**SITE PLAN: LOT 409, PHASE 5,
THE PARKE AT OCEAN PINES, SECTION 16 OF OCEAN PINES,
THIRD TAX DISTRICT, WORCESTER COUNTY, MARYLAND**

SOULÉ & ASSOCIATES
ENGINEERING / SURVEYING / PLANNING
122 ARLINGTON ROAD
ARLINGTON BUSINESS CENTER
SALISBURY, MARYLAND 21801
(410) 742-7797

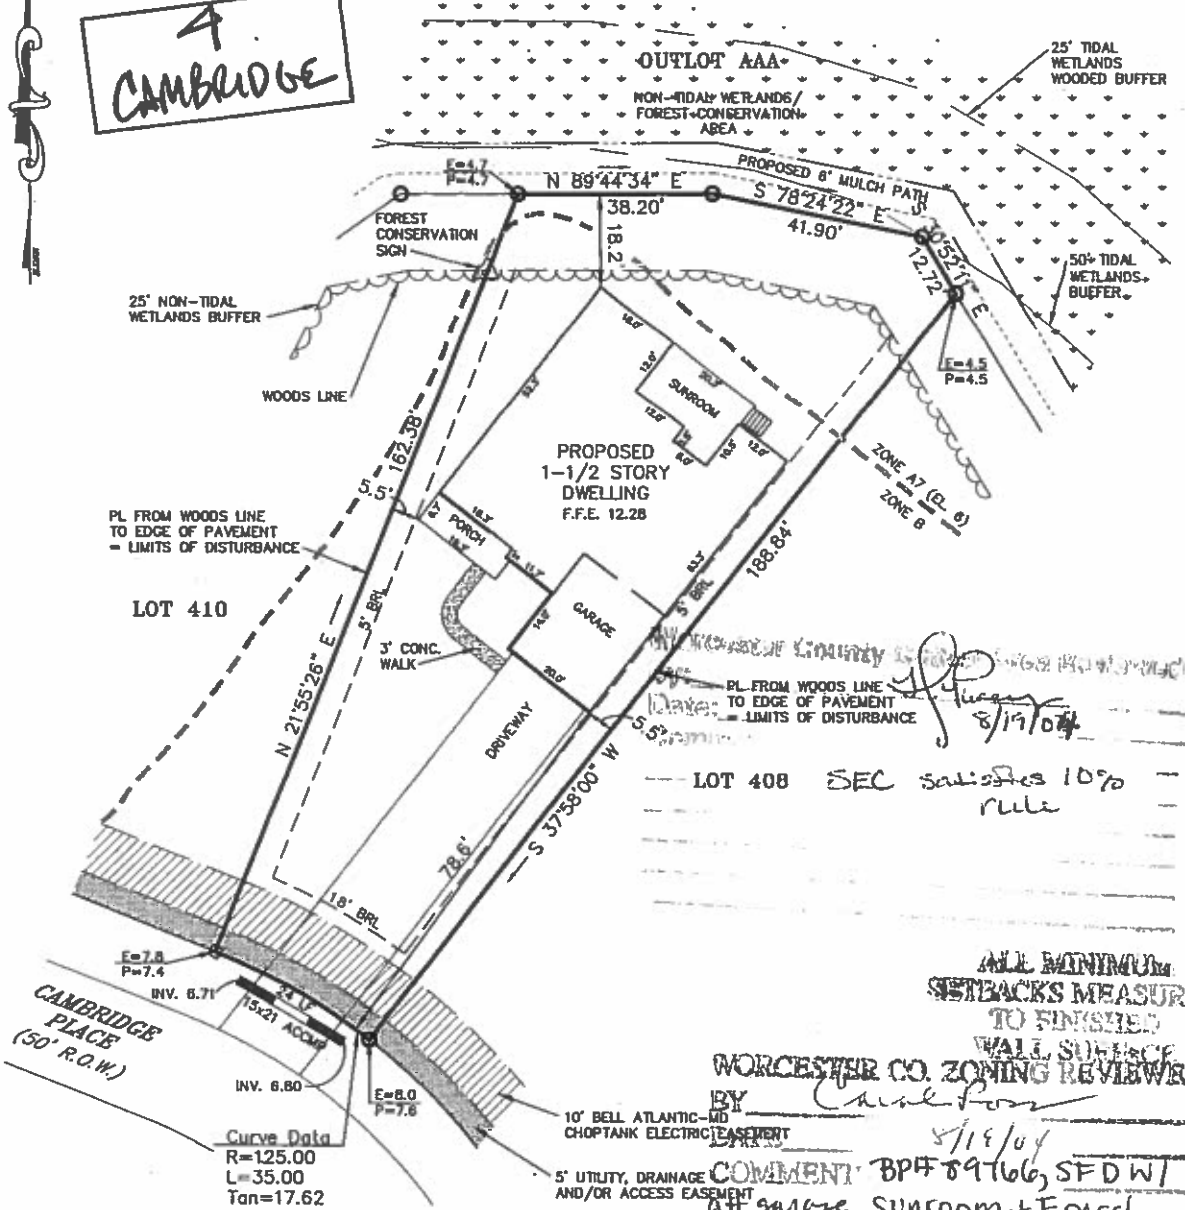
Worcester County Planning & Zoning Department
Date: 8/19/04
LOT 408 SEC satisfies 10% rule
ALL MINIMUM SETBACKS MEASURE TO FINISHED WALL SURFACE
WORCESTER CO. ZONING REVIEWED BY _____ 8/19/04
COMMENT: BPF 89766, SFD W/ att garage, sunroom + F porch
att. w/ SWM/SEC # 89767
TM21, P311, S16, L409
